UNITED STATES
NUCLEAR REGULATORY COMMISSION

APPLICANT: Tennessee Valley Authority (TVA)
FACILITY: Watts Bar Nuclear Plant, Units 1 and 2
SUBJECT: MEETING SUMMARY - OCTOBER 13, 1993 MANAGEMENT MEETING
ON USE OF U-BOLTS AS PIPE CLAMPS (TAC M79718)
REFERENCE: Meeting Notice by P. S. Tam, September 21, 1993

LIST OF PARTICIPANTS AND OBSERVERS
MANAGEMENT MEETING ON USE OF U-BOLTS AT WATTS BAR
October 13, 1993

FIG. 9 - TIGHT FIT U-BOLTS IN TRAPEZE ASSEMBLIES

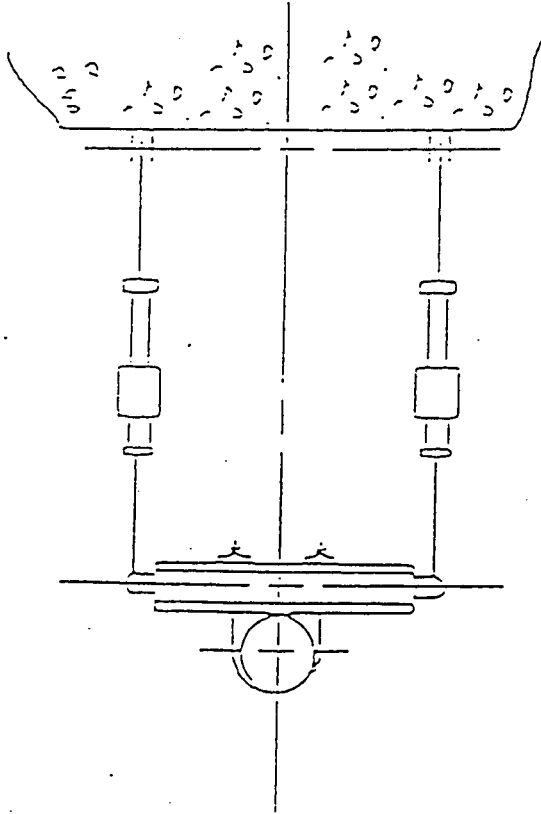
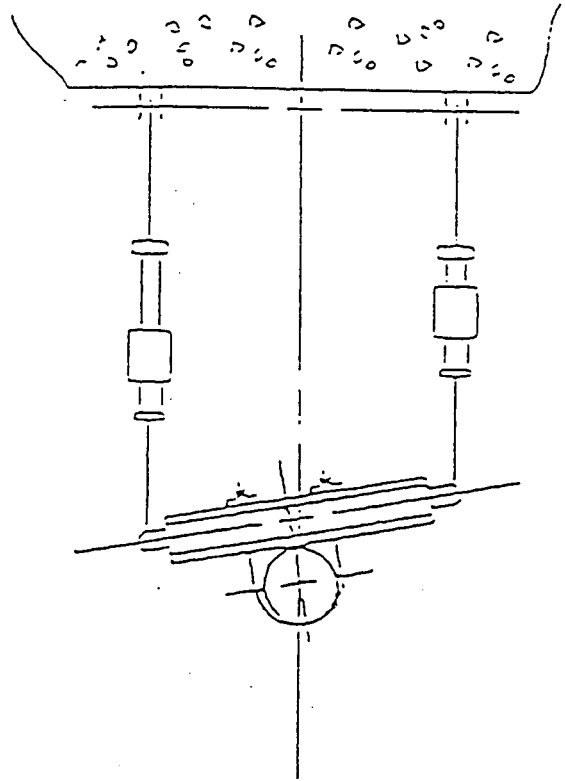
SECTION 2.4.5.3 TRAPEZE ASSEMBLIES "TIGHT-FIT U-BOLTS ARE OFTEN USED IN SUPPORT ASSEMBLIES TO PROVIDE SUPPORT IN ONE DIRECTION FOR ROD HANGERS AND TWO DIRECTIONS FOR STRUTS AND SNUBBERS. THE LATTER DESIGN IS NOT RECOMMENDED (REFER TO SECTION 2.4.1) FOR STABILITY REASONS."

- CLARIFICATION OF WBN SUPPORTS
 - ROD HANGERS ON SAFETY PIPING USED IN ONE DIRECTION ONLY.
 - U-BOLTS WITH STRUTS OR SNUBBERS USED IN VERTICAL OR LATERAL DIRECTION ONLY.
 - WRC 353, SECTION 2.4.5.3 CONTINUES WITH:

"IN THESE TYPE OF APPLICATIONS, THE U-BOLT IS PRIMARILY IN TENSION. THIS TYPE OF SUPPORT CAN BE USED FOR ALL SIZES OF PIPE. SEE FIGURES 6 AND 9."
- WBN PERFORMED INSITU TESTING TO VERIFY STABILITY
- WRC 353 PROVIDES SPECIFIC GUIDANCE FOR USE OF U-BOLTS
 - WBN COMPLIES WITH DO'S AND DON'TS
